## ADDENDUM NO. 02

Date of Issuance: January 24, 2025

Project: **2024 Cypress Falls HS Renovation**  
Cypress-Fairbanks Independent School District

Texas Arcadis Inc.  
Project No.: 202318

**G1.06**

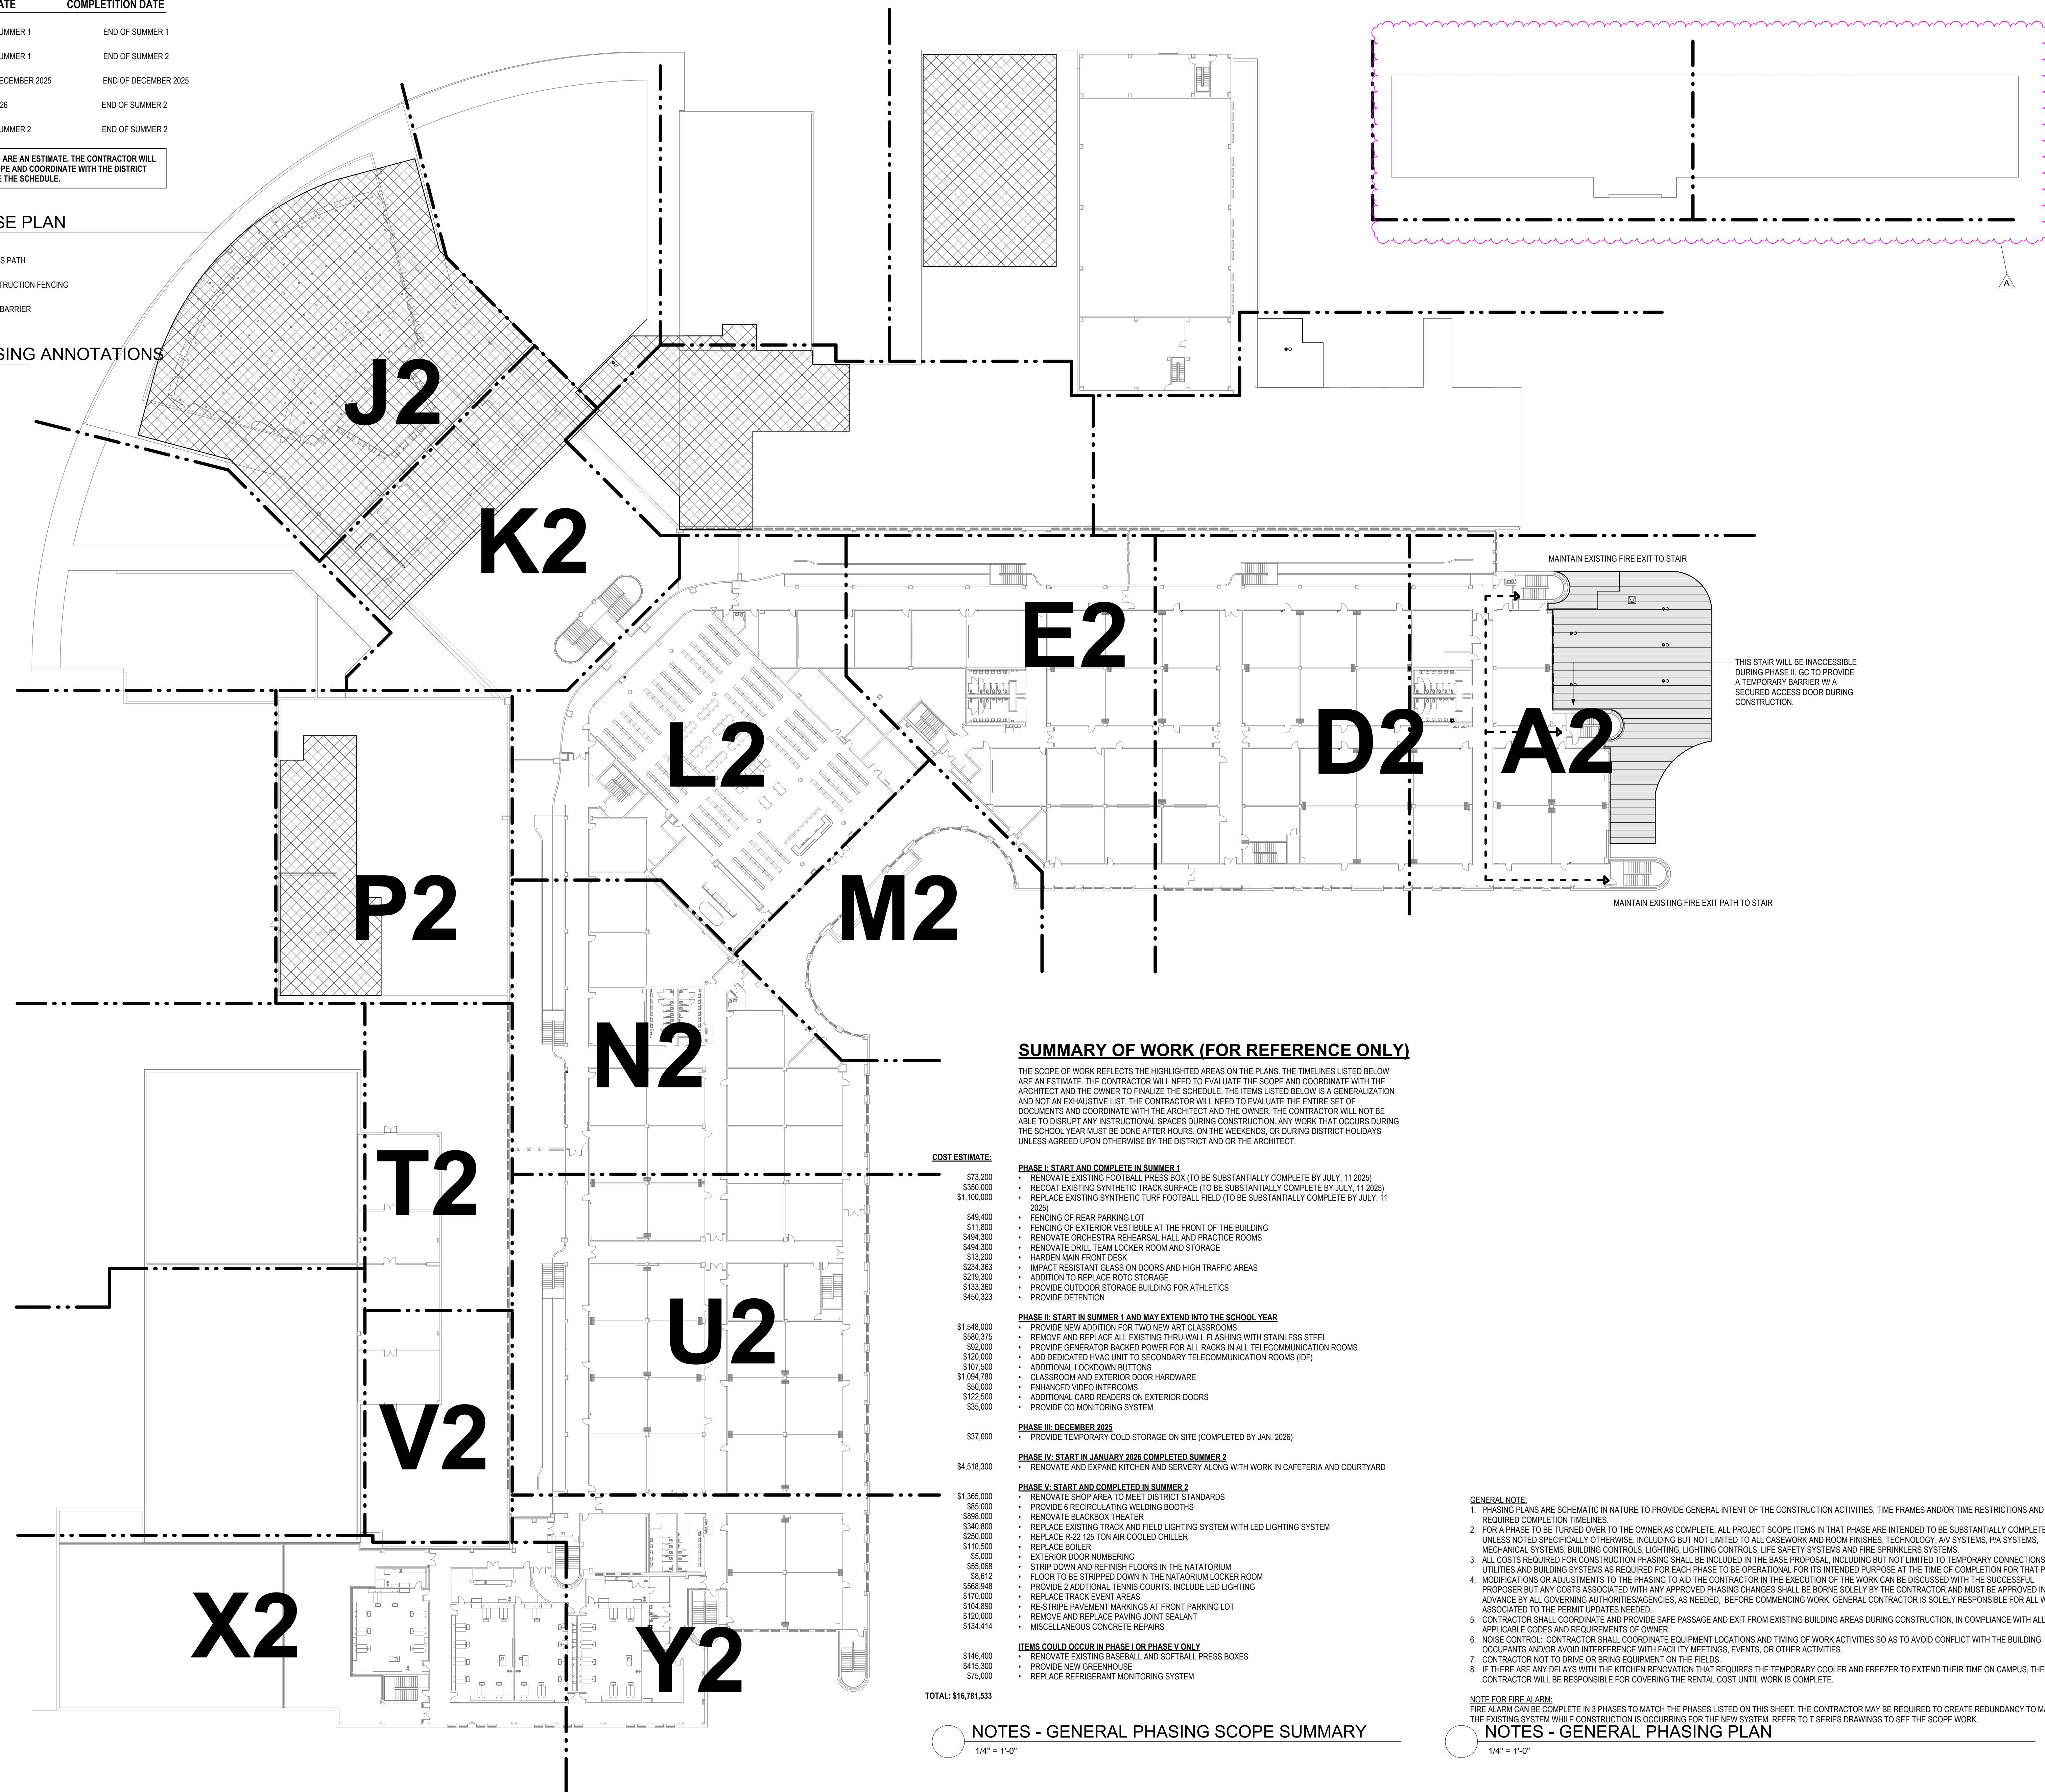
- b. Added existing floor grates at the temporary cooler and freezer location.
23. Sheet G1.06 – 2<sup>ND</sup> FLOOR PHASING SHEET
- a. View revised to show cut off part of the building.

**1 DEMO SITE PLAN - S5**  
1" = 30'-0"

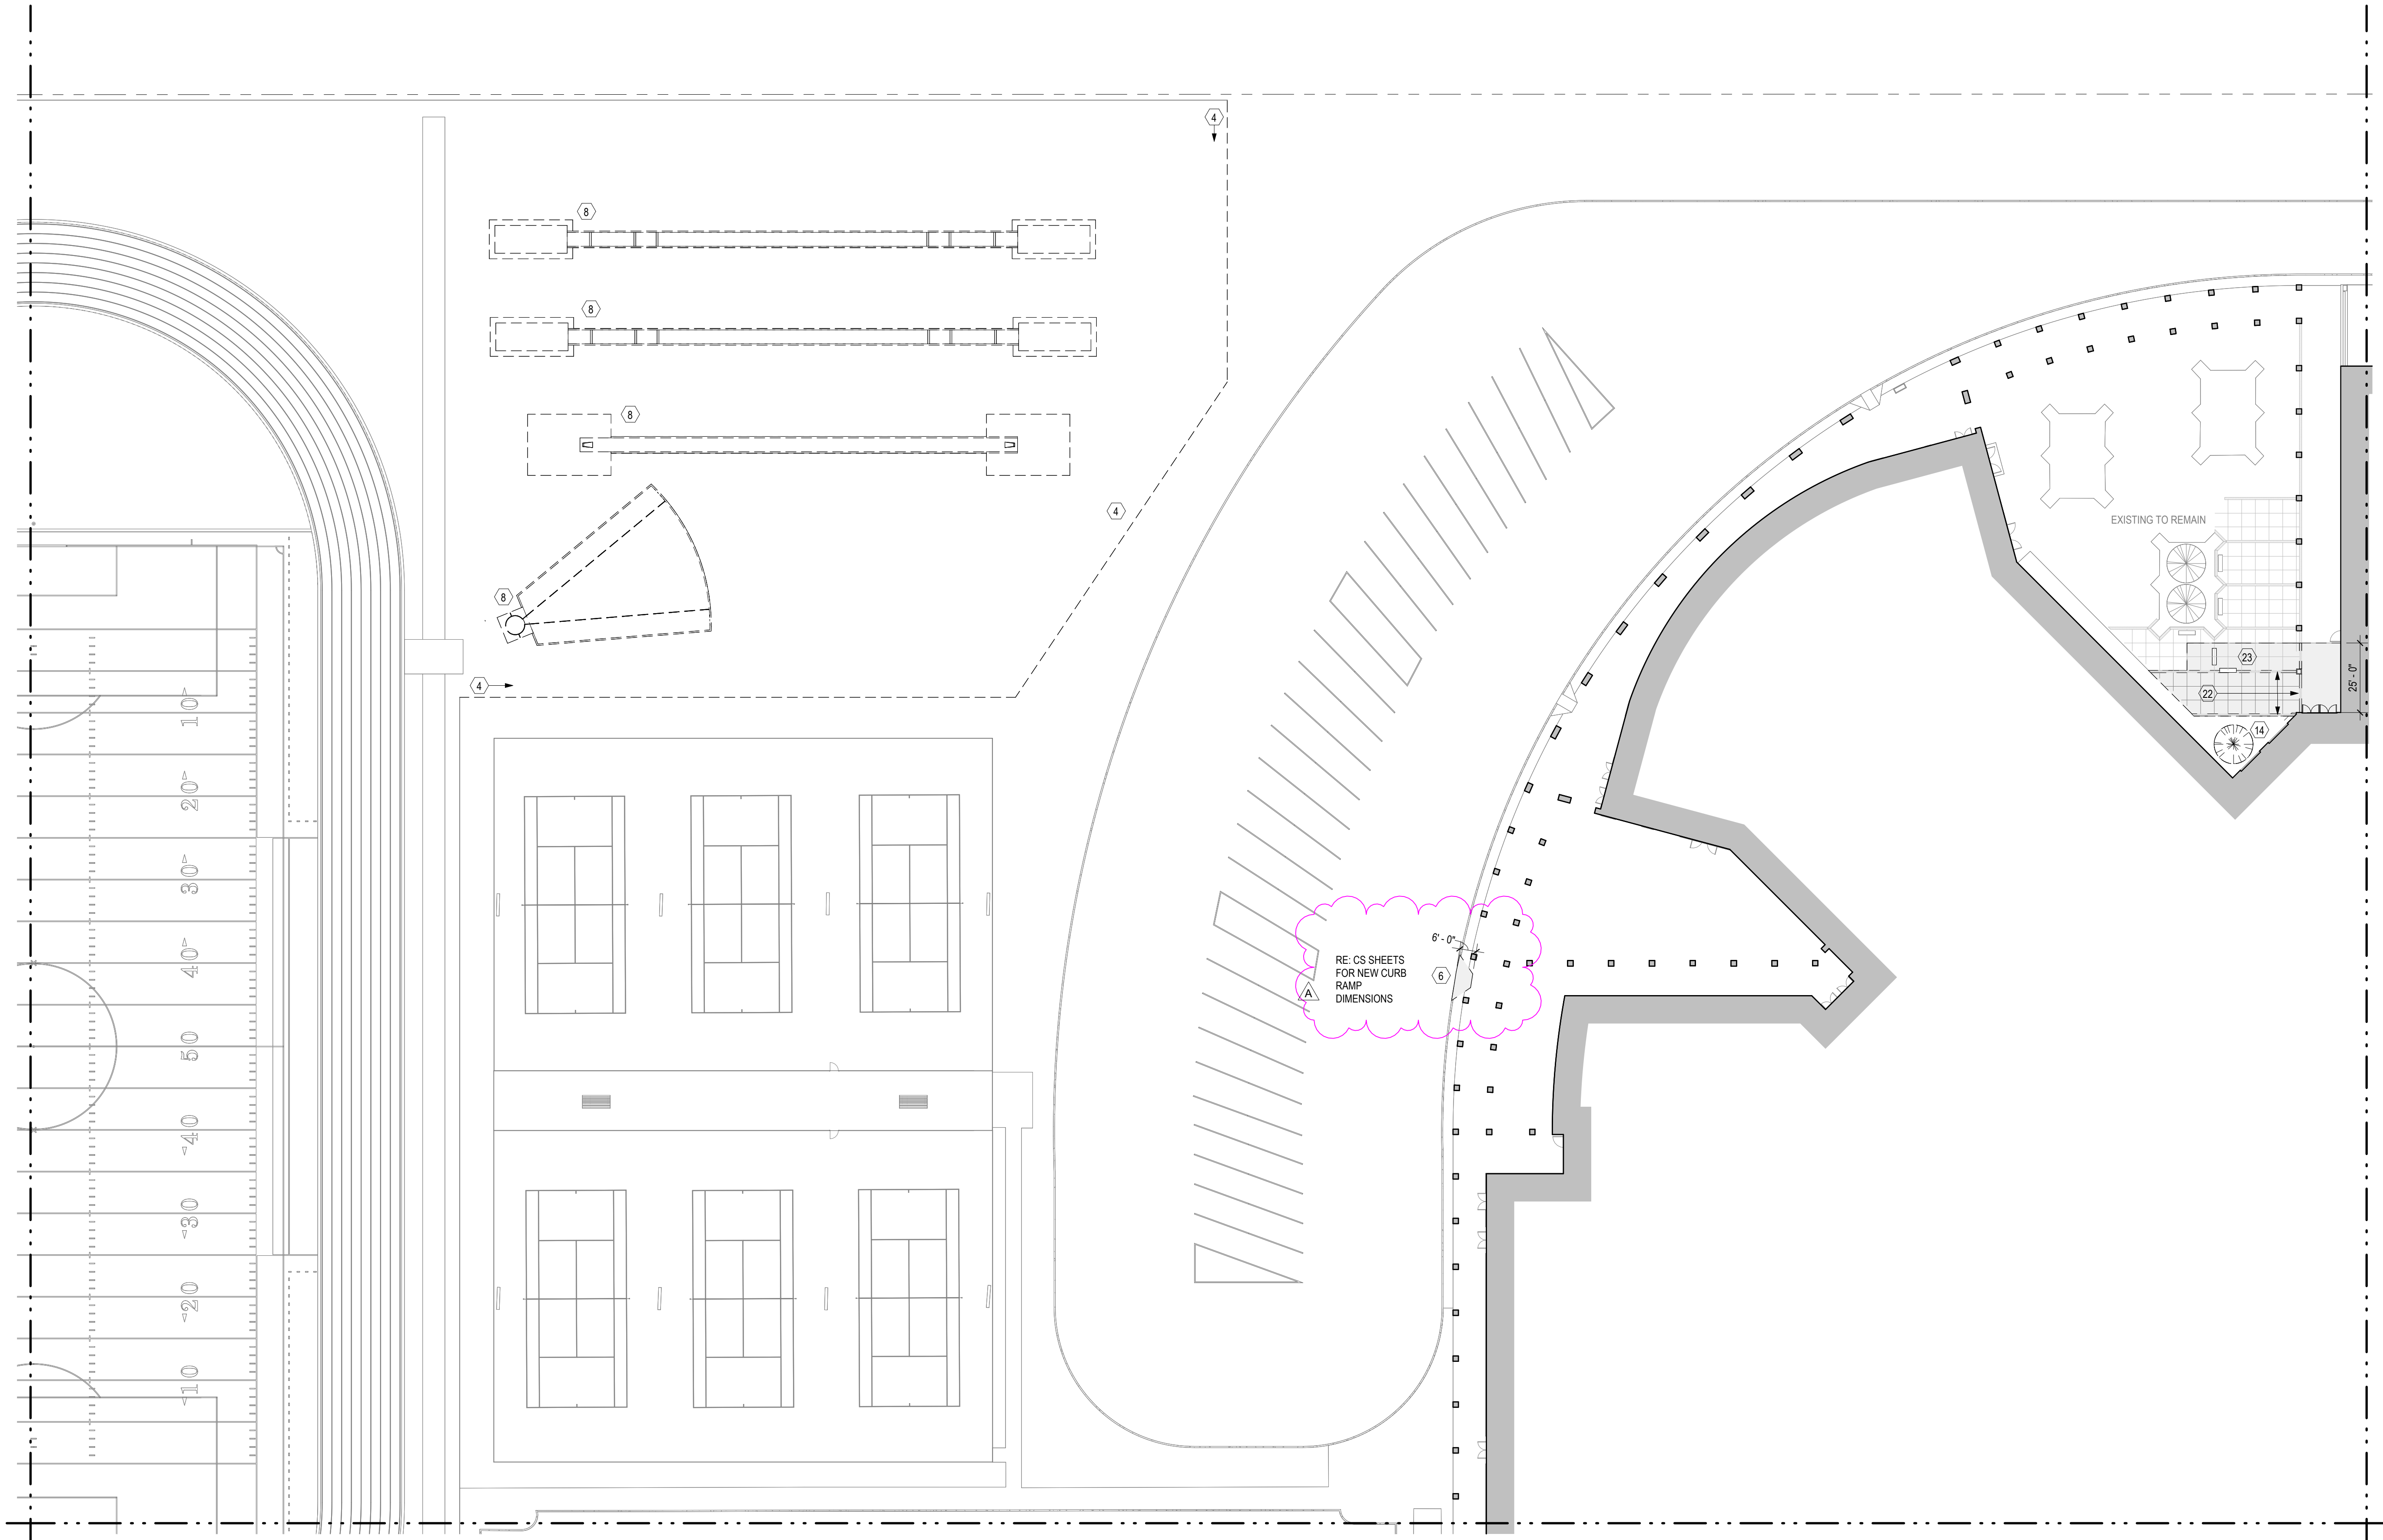
25. Sheet C0.05 – DEMO SITE PLAN – AREA 'S5'
- a. Revise demo keynote 6 in demo keynote legend, "EXISTING CURB AND FLATWORK TO BE DEMOLISHED."
  - b. Show demo scope for new curb ramp near temporary kitchen equipment at northwest entry. Add demo keynote 6 and a note, "RE: CS SHEETS FOR NEW CURB RAMP DIMENSIONS."

## 1 SITE PLAN - AREA 'S5'

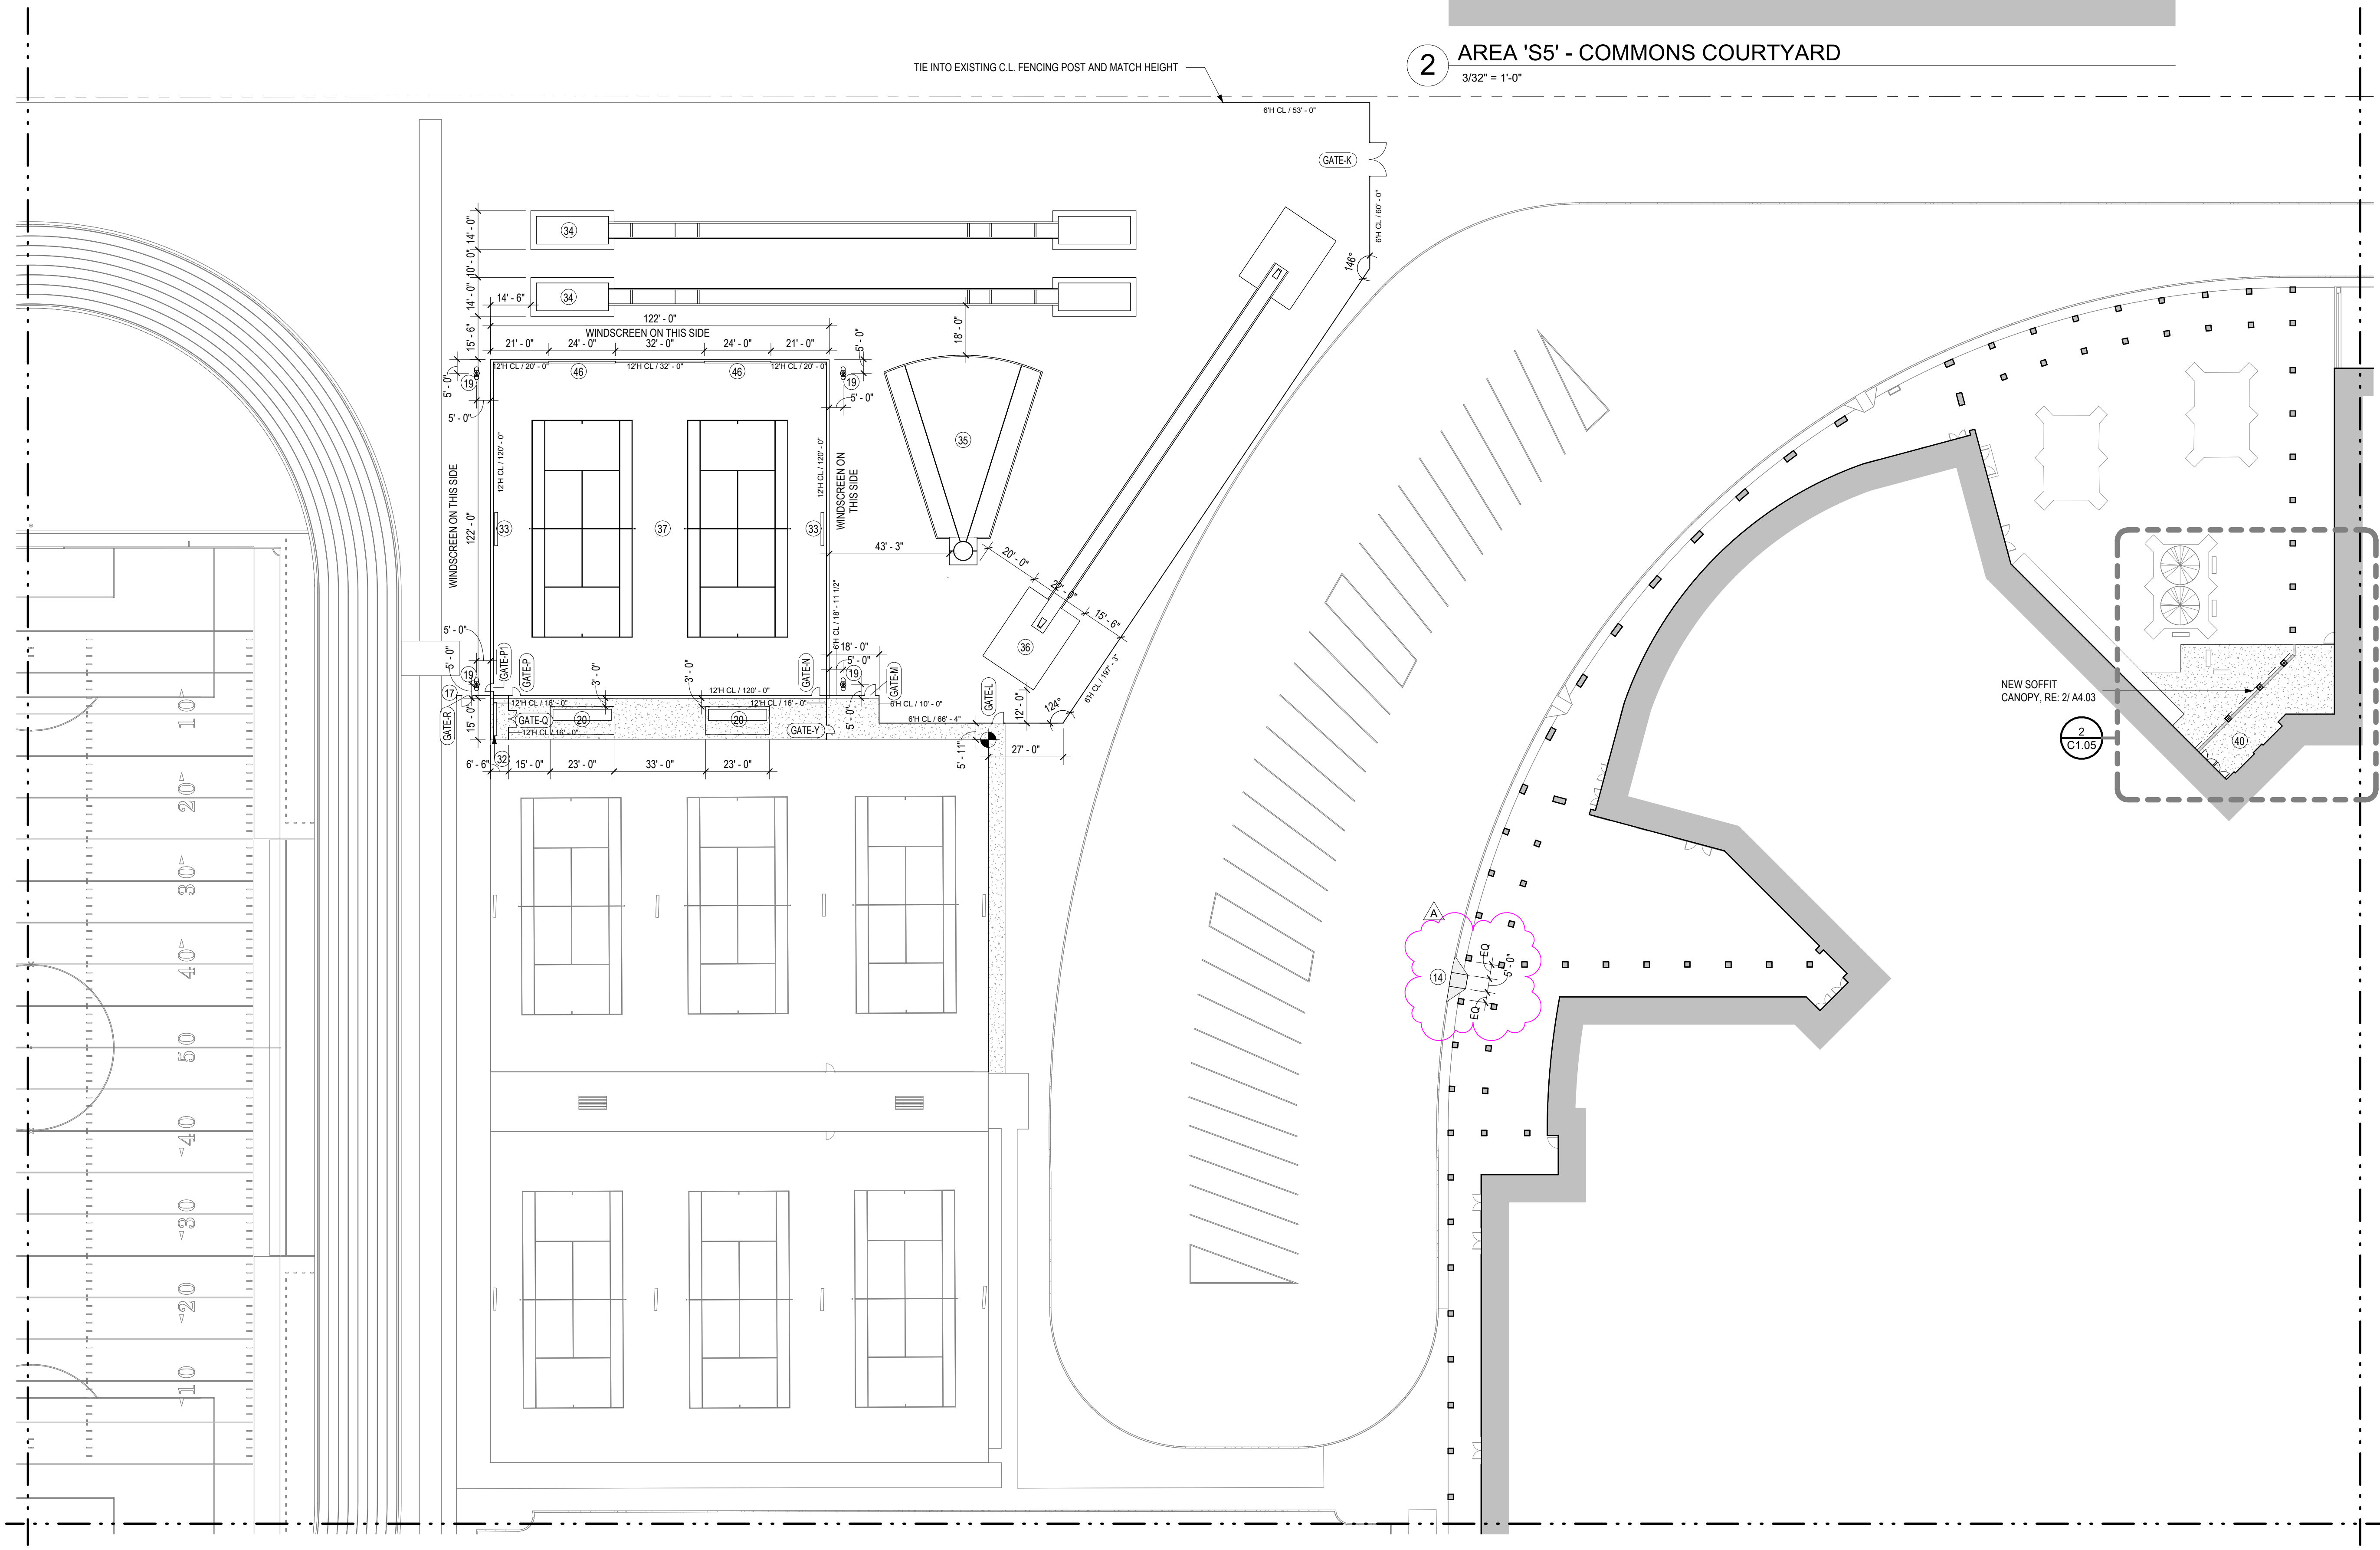
30. Sheet C1.05 - SITE PLAN AREA 'S5'
  - a. Added new curb ramp at the northwest entry.
  - b. Revised keynote 4.
  - c. Revised keynote 14.
  - d. Revised site plan keynote 38.
